# INSTALLATION OF SEASTAR CYLINDER HC5331 CABLE TUBE SUPPORT KIT# 785255

Teleflex Canada has learned of a few isolated cases where the cable tube has cracked on the Volvo Power Steering drives, SX, DP-S and XDP, causing loss of steering control. Please read the following inspection and installation procedures to ensure your system is operating properly.

Figure A

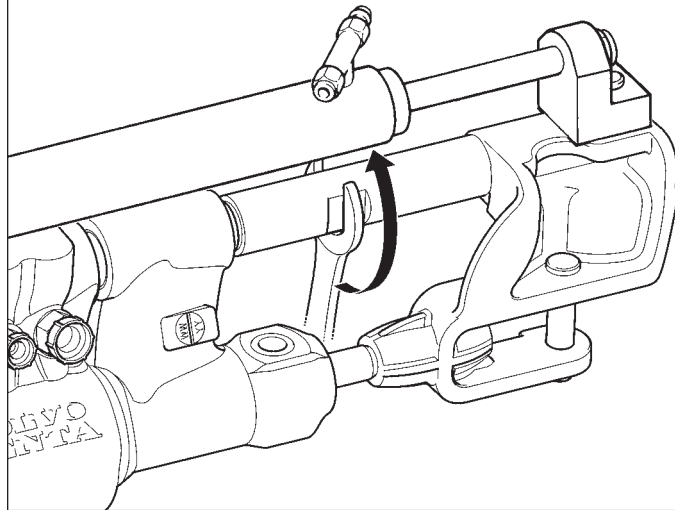
Ensure that the cable tube is fully tightened. To do so place a wrench onto the cable tube wrench flats and tighten in the direction shown in Figure A. Torque to 40 ft-lb. (54.25Nm).

Figure B

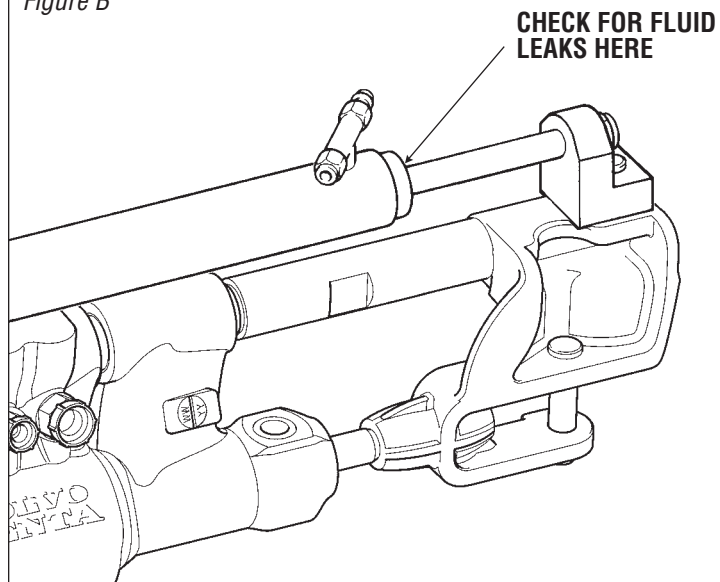
During inspection also check for signs of hydraulic fluid leaking in the area noted in figure B.

Figure C

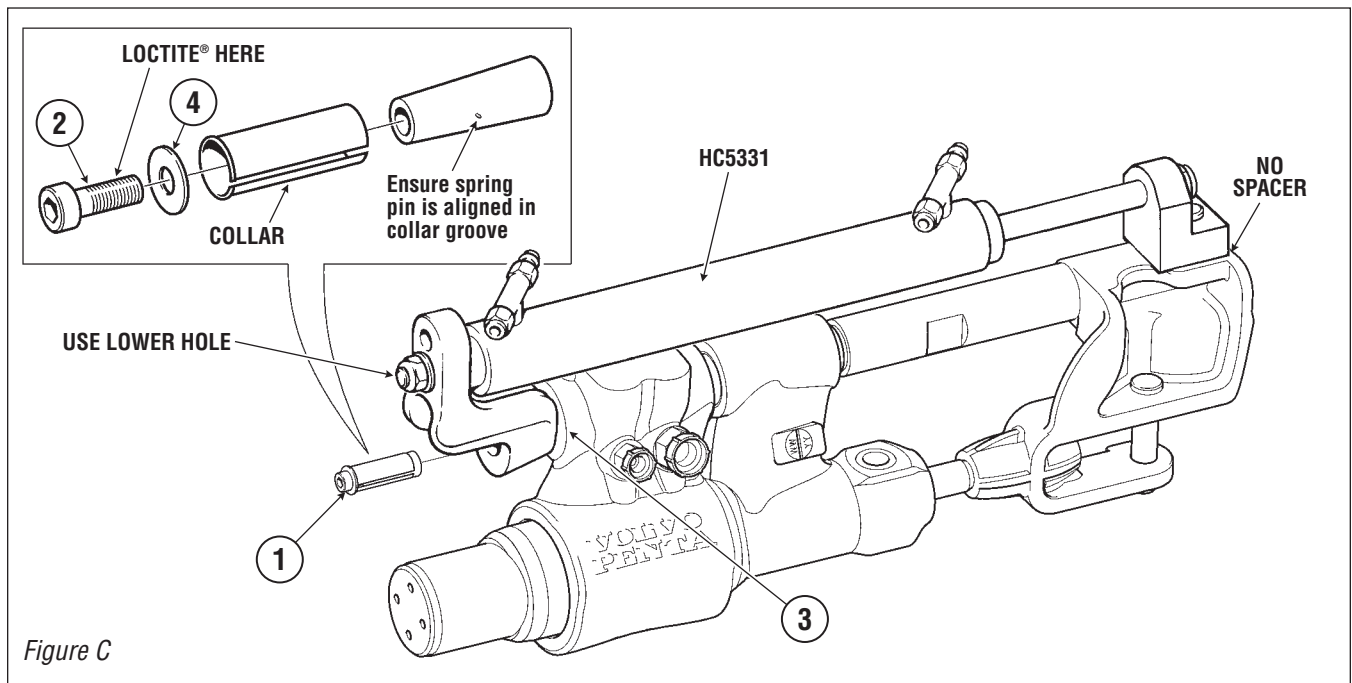
**STEP 1:** BEFORE installing the Tube Support Kit#785255 (figure C, item #1) ensure that the 1/4" screw (figure C, item #2):

- **HAS** Loctite® applied to the threads
- **IS NOT** tight
- **IS** loosened by two turns

**STEP 2:** Push the Tube Support (figure C, item 1) into the tube (figure C, item 3) by pressing on the 1/4" screw (figure C, item 2) **DON'T press on the washer** (figure C, item 4). Refer to notice on left. Ensure that the tube support (figure C, item 1) and tilt tube bore are clean and free of any oil or debris.

**STEP 3:** Once installed torque the 1/4" Screw (figure C, item 2) to 160in-lb (18.5Nm).

**STEP 4:** Repositioning of cylinder—Please change the location of the steering cylinder to the lower hole in the cylinder bracket and remove the cylinder spacer (refer to figure C).
